Access Compliance Report

Public Rights-of-Way

Intersection ID: 30005	Main Street: BACKWATER_DR	Cross Street: BRIGHTHAVEN_LN	Location: SE
ADA ID: 4FDC38E74D94	Ramp Type: BlendTrans1	Initial Pass/Fail: Fail	Overall Compliance: No
		Severity Score: 25

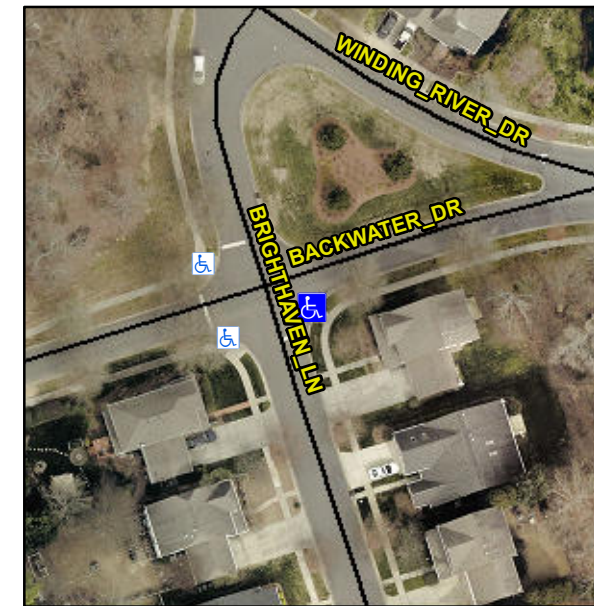
Not Found, R304.5.3

Compliance	Description	Data	Compliance	Description	Data
N/A	Ramp Length (in)	71.0	Yes	BlendTrans Slope (%)	4.0
Yes	Ramp Width (in)	48.0	No	BlendTrans XSlope (%)	8.3
N/A	Flare Type LT	N/A	N/A	Flare Type RT	N/A
N/A	Flare Slope LT (%)	N/A	N/A	Flare Slope RT (%)	N/A
N/A	Flare Traversable LT?	N/A	N/A	Flare Traversable RT?	N/A
N/A	Landing Length (in)	N/A	N/A	DWS Provided?	N/A
N/A	Landing Width (in)	N/A	N/A	DWS Contrast?	N/A
N/A	Landing Slope (%)	N/A	N/A	DWS Length (in)	N/A
N/A	Landing X Slope (%)	N/A	N/A	DWS Full Width?	N/A
N/A	Landing Curb? (Y/N)	N/A	N/A	DWS Offset (in)	N/A
N/A	Shared Landing?	N/A			
N/A	Gutter Ponding?	N/A	N/A	Gutter Slope (%)	N/A
N/A	Gutter Lip Ht (in)	N/A	N/A	Gutter X Slope (%)	N/A
N/A	Painted X Walk1?	No	N/A	Painted X Walk2?	N/A
	X Walk 1 Direction	To SW		X Walk 2 Direction	N/A
	X Walk 1 Width (in)	N/A		X Walk 2 Width (in)	N/A
	X Walk 1 Slope (%)	0.6		X Walk 2 Slope (%)	N/A
	X Walk 1 X Slope (%)	4.2		X Walk 2 X Slope (%)	N/A

Remove & Replace Curb Ramp With Two New Directional Ramps or Equivalent.
